### **Levin Landfill Biofilter Technical Review**

MWH New Zealand Limited (MWH) was engaged by the Horowhenua District Council (HDC) to provide technical comments on its document entitled 'Design Report: Odour Bio-filter for Levin Landfill' (referred to hereafter as the 'design report') dated July 2016. Our comments are set out below. It is noted that no concept or detailed design drawings of the biofilter were included in the design report.

Figure 4-1: Schematic Plan View of the Biofilter at Levin Landfill

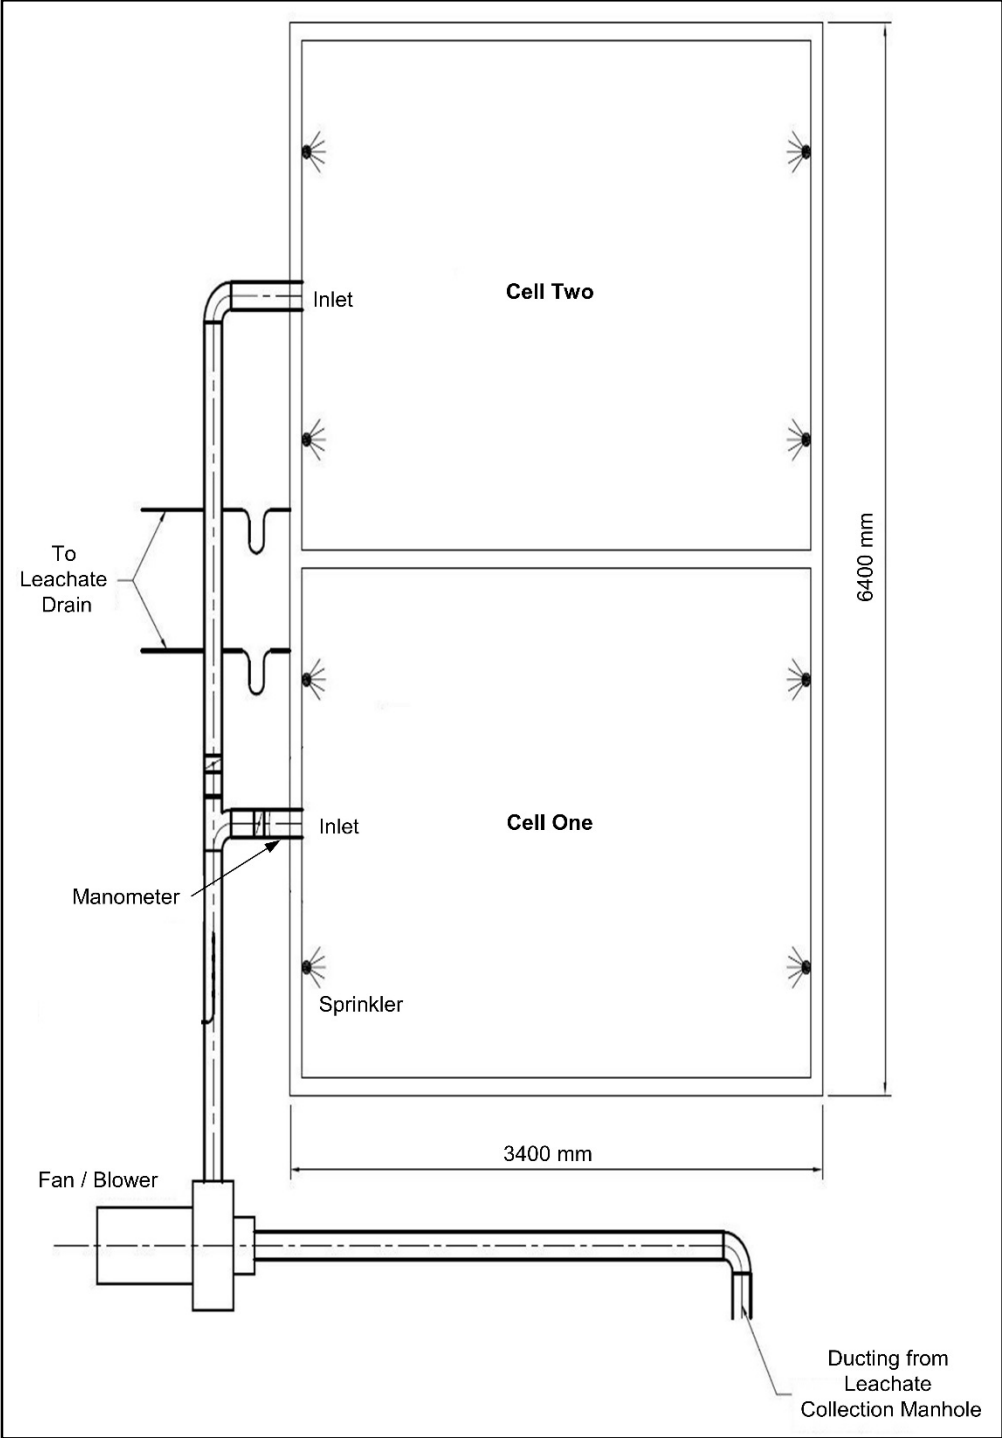
The proposed biofilter structure should comprise of a concrete slab with concrete block walls (200 mm width) and under-drainage to remove biofilter-derived leachate (see later note).

There should be an open plenum of a depth of at least 200 mm under the media and an internal polypropylene geo-membrane liner should be placed around the side walls and base of the structure to protect the concrete and to collect leachate. The purpose of the plenum is to distribute the incoming odorous air evenly beneath the biofilter media via pipework. Concrete blocks or open plastic box structures (e.g. Atlantis matrix mini modules) could be considered to be placed within the plenum, rather than stone pebbles or limestone chips (to provide greater porosity) and a 6 mm (1/4 inch) polypropylene 'oyster drainage mesh' should be placed above the liner (overlap) and drainage cells to provide adequate support to the media, rather than a 100 mm mesh stated in the design report (to ensure that the bark chips do not fall into the plenum where they could block the pipework).

The inlet duct should be made of galvanised mild steel (as opposed to PVC, as indicated in the design report) as it will be necessary to attach sampling ports and fittings, and the leachate/condensate drain will be made of PVC.

An inclined manometer should be fitted to the inlet duct to the biofilter as shown in Figure 4–1 to allow the pressure drop over the biofilter media (the difference between the inlet pressure and the ambient pressure) to be determined on a weekly basis, or as required. The manometer could be fitted to a 5-6 mm barbed pipe attached to the inlet duct.
